scheme 4: revisions to scheme 3

PROJECT
 The Hood, Scheme 2
 17 Lyndhurst Gardens,
 Hampstead, London
 Returning A Great Victorian House To Phased Domestic Accommodation
 NW3 5NU

DRAWING
 Sections CC-EE
 as Proposed

DRAWING NO	REVISION
19013	L

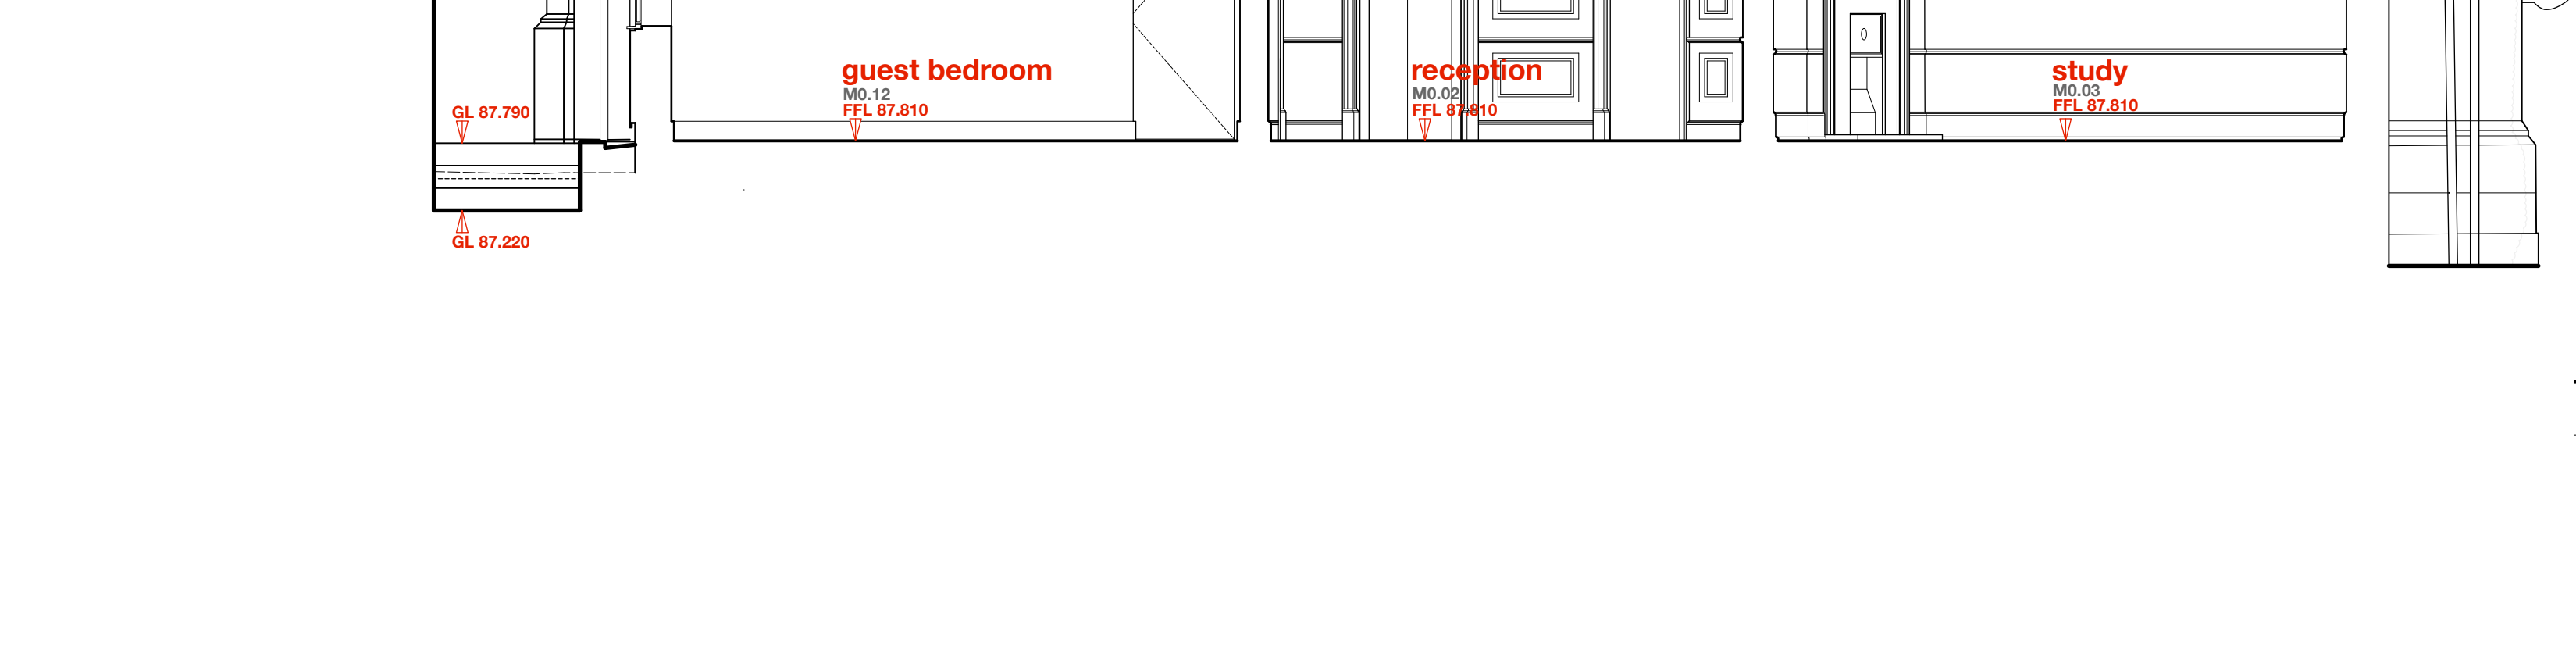
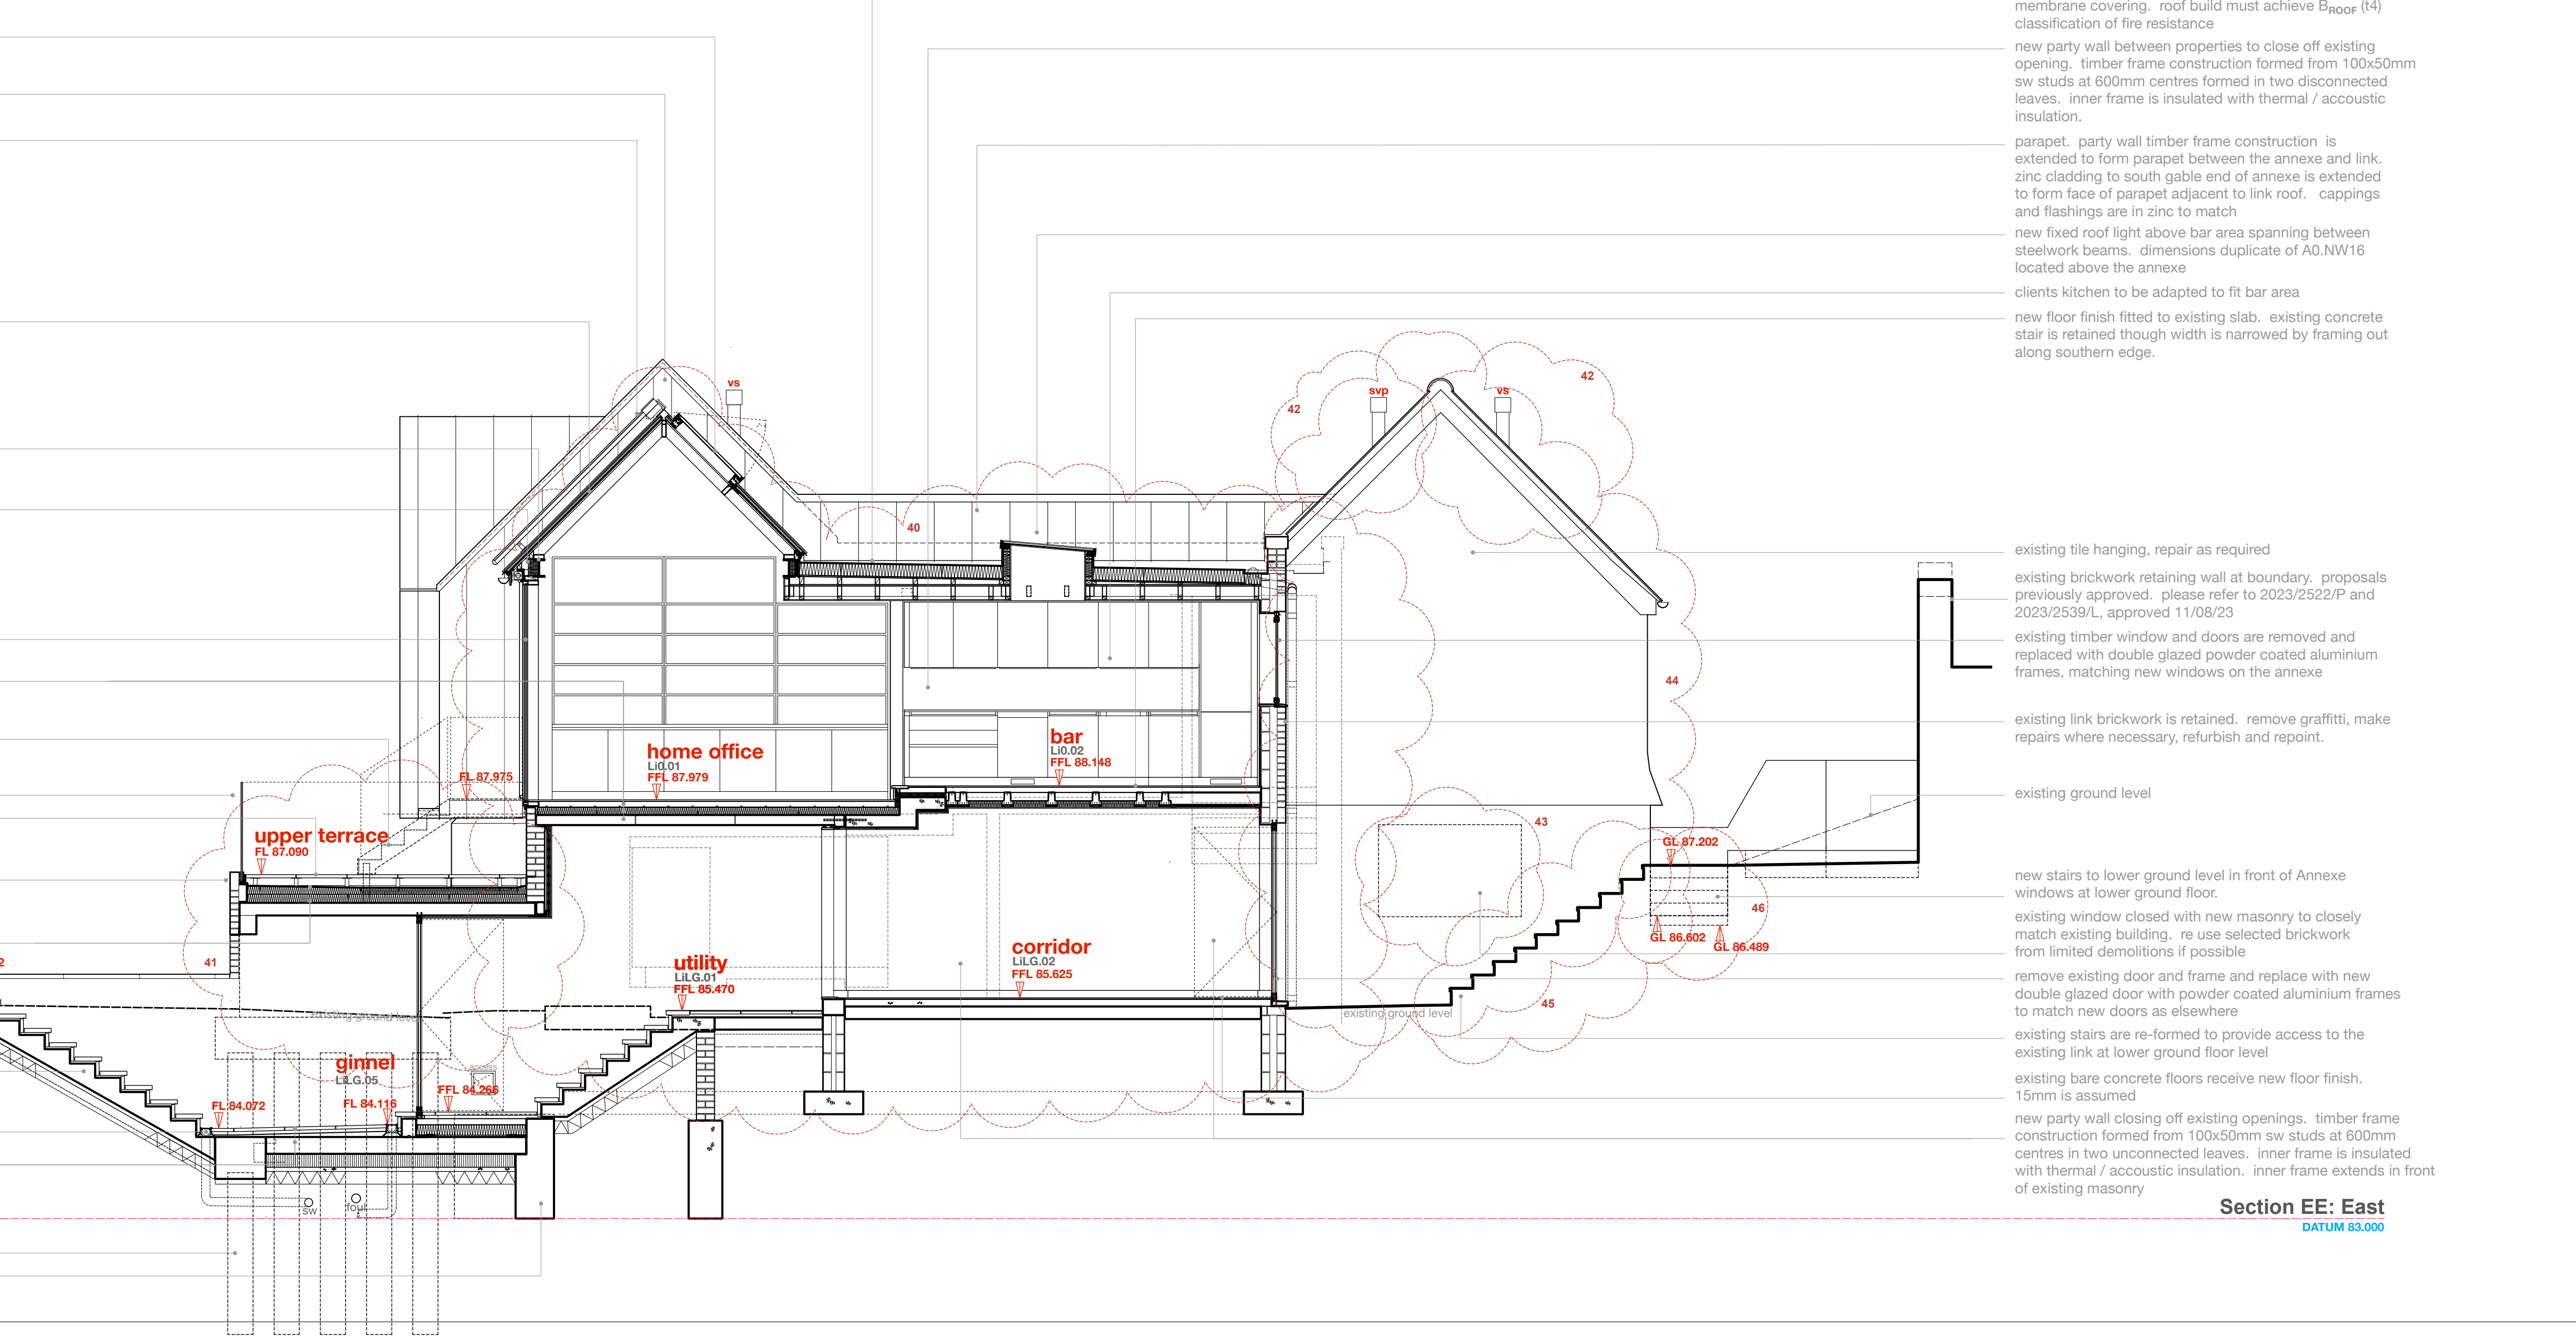
- 40 link: contemporary new build link and existing structures are omitted, underpinning to the rear house and annex is omitted, existing link is retained to the proposed scheme, minor adjustments to glass cladding of the annex to suit the revised profile of the link

- 41 link: undercroft structure providing access to the lower ground floor of the redesigned link is simplified, hard and soft landscaping is extended from the main house and levels revised to suit the elevated structure, the look of the hard and soft landscaping is reduced to suit the lower-key building, with the smaller mass and scale lessening the impact on the main house

- 42 annex: rooftop dormers containing plenum boxes are omitted
- 43 annex: elevation is no longer concealed by the link, new brickwork to close former openings, brickwork should match adjacent existing brickwork closely

- 44 annex: elevation is no longer incorporated into the link, existing brick and hanging sills should be repaired as required, repaired and cleaned, new stain coating to timber surfaces

- 45 annex: external levels are returned to existing arrangements to allow access to the link at lower ground and ground levels on the north elevation
- 46 external staircase leading to lightwell at rear of annex simplified and returned through 90 degrees, levels and falls in front of windows ALG.NW10 and ALG.NW11 are lowered and falls improved
